THM 440-T4 NEW PRESSURE SWITCH AND HARNESS

CHANGE: Beginning on September 6, 1989 (Julian Date 249) SOME, 440-T4 transaxles will be built

Figure 1

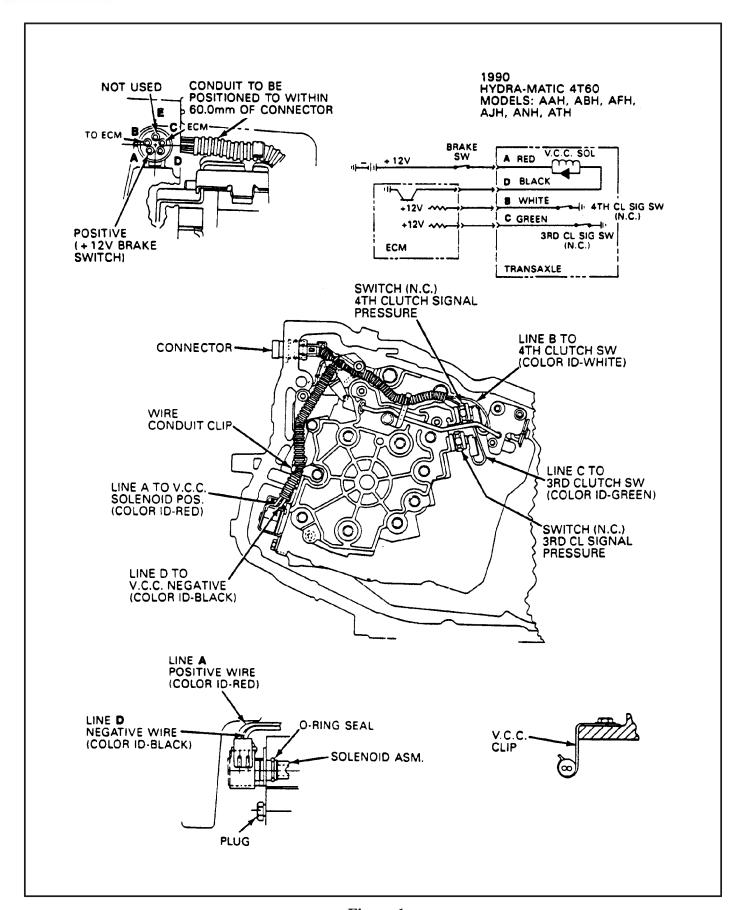
- (1) PRESSURE SWITCHES The new 2nd, 3rd, and 4th clutch pressure switches will have "Button" head wire connectors instead of the "Blade" type connectors (See Figure 1).
- (2) WIRING HARNESS The new wiring harness will have different type connectors to accommodate the new "Button" head switches. Refer to Figures 2, 3, and 4 for wiring harnesses.
